VIRGINIA ELECTRIC AND POWER COMPANY
NORTH ANNA POWER STATION UNIT 1
ASME SECTION XI INSERVICE INSPECTION PROGRAM
REQUEST FOR ALTERNATIVE EXAMINATION

**Alternative Examination Coverage
Reactor Vessel Shell Welds**

**Virginia Electric and Power Company
North Anna Power Station Unit 1**

**REQUEST FOR ALTERNATIVE
TO THE REQUIREMENTS OF
10 CFR 50.55a(g)(6)(ii)(A)**

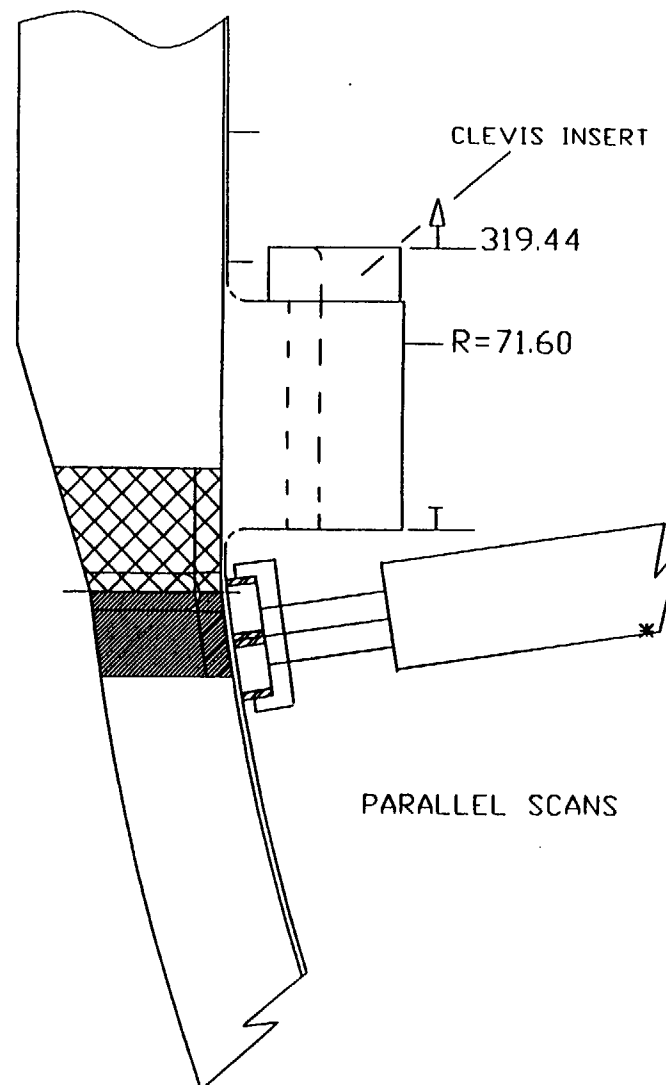
The examination volumes for Welds 2 and 3 were 100% of the required coverage. The examination volume for Weld 4 was less than 90 % due to interference from four integrally attached core support lugs located on the vessel interior. Table 1 provides a summary of the limitations associated with the examination of Weld 4. Amplifying sketches are also provided in Figures 1 and 2. Alternative components could not be substituted for examination due to the mandatory selection requirements of the ASME Code and 10 CFR 50.55a(g)(6)(ii)(A).

As shown in Table 1, the Weld 4 examinations covered 80.86% for a beam angle of 45° shear wave, 81.1% for a beam angle of 60° shear wave, and 78.63% for a beam angle of 70° refracted longitudinal wave. However, because the examination volumes of Welds 2 and 3 were each 100%, the total volume

examined for all three welds was greater than 93% of the total volume subject to the requirements of 10 CFR 50.55a(g)(6)(ii)(A). The examination of over 93% of the required total volume for the three welds provides reasonable assurance that unacceptable service induced flaws have not developed and that the reactor vessel shell weld integrity is maintained. Also, these examinations provide an acceptable level of quality and safety. Therefore, as an alternative to examining greater than 90% of each weld examination volume as described in 10 CFR 50.55a(g)(6)(ii)(A), it is proposed that the examinations of Welds 2, 3 and 4 be taken as a whole and the total coverage be over 93% of the sum of the required examination volumes for Welds 2, 3 and 4.
